MATERIAL	Chinese steel 45	PART No	40749-6PT-4FS-4NWO
FINISH	Remove all sharp edges, burrs, slivers and snags, break all corners 0.127-0.254mm. ZINC PLATING WITH 7um MICRONS MINIMUM PLATING THICKNESS AND TRivalent CHROMATE PASSIVATION AND WITHSTAND 96 HRS TO WHITE / 144 HRS TO RED RUST IN SALT SPRAY TEST.	SCALE:	1:1
		DATE:	28/06/16
		CHK:	LJ Jumbiao
		APPD:	Zhang
		DRN:	LYongHua
		制图	2016.06.15
		审核	2016.06.15

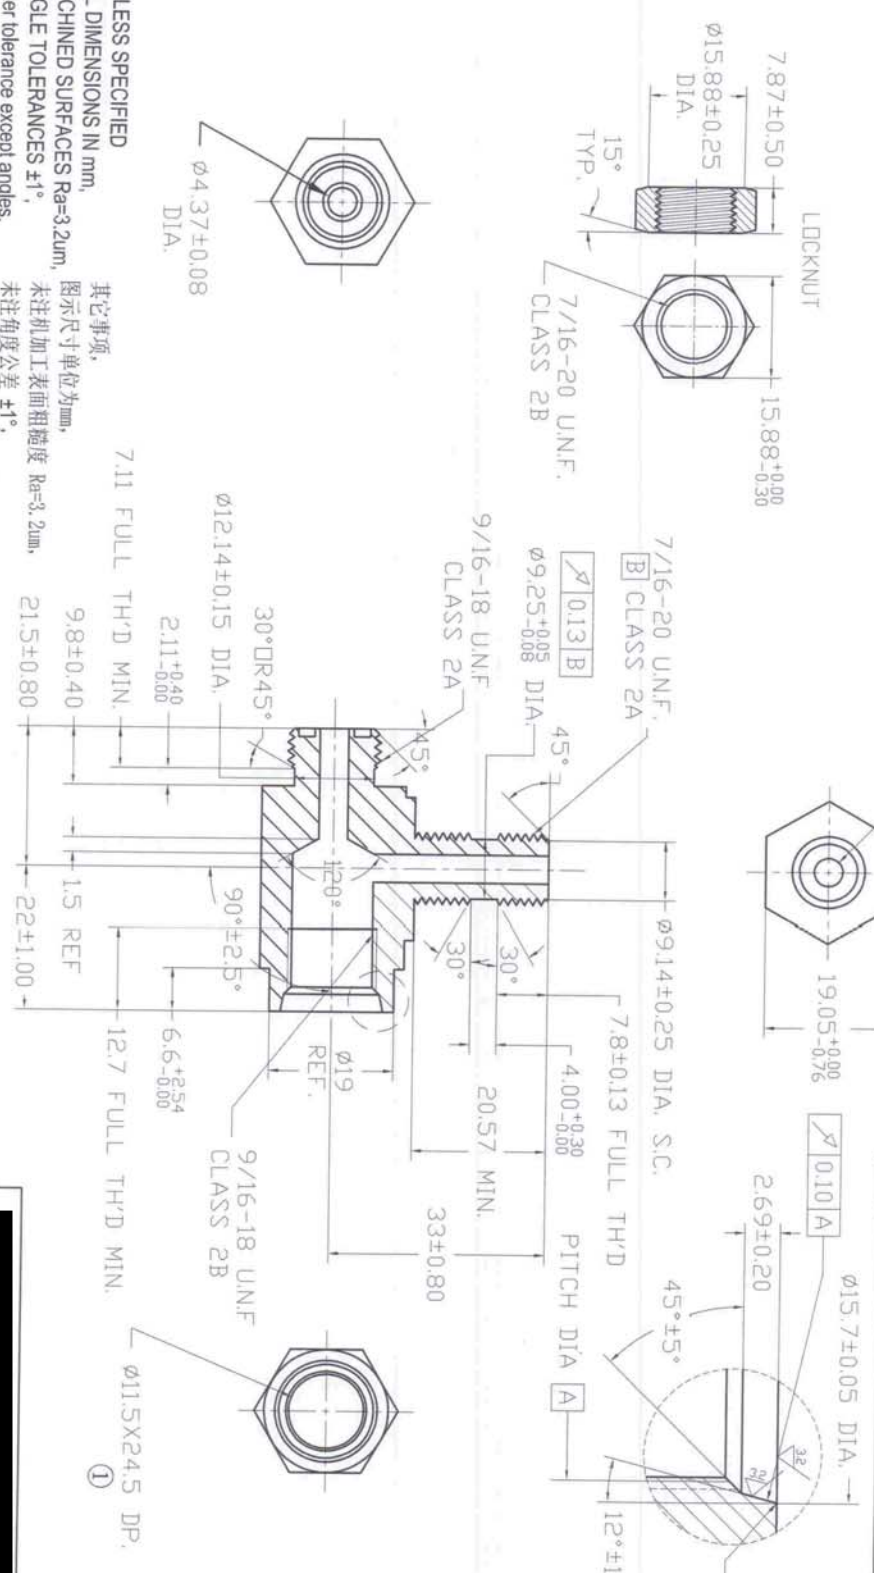
REV	DATE	REVISION DETAILS	APPD
更改号	日期	更改内容	审核并批准
①	16.06.14	7.54+/-0.10x24DP changed to Dia.11.3x24.5DP
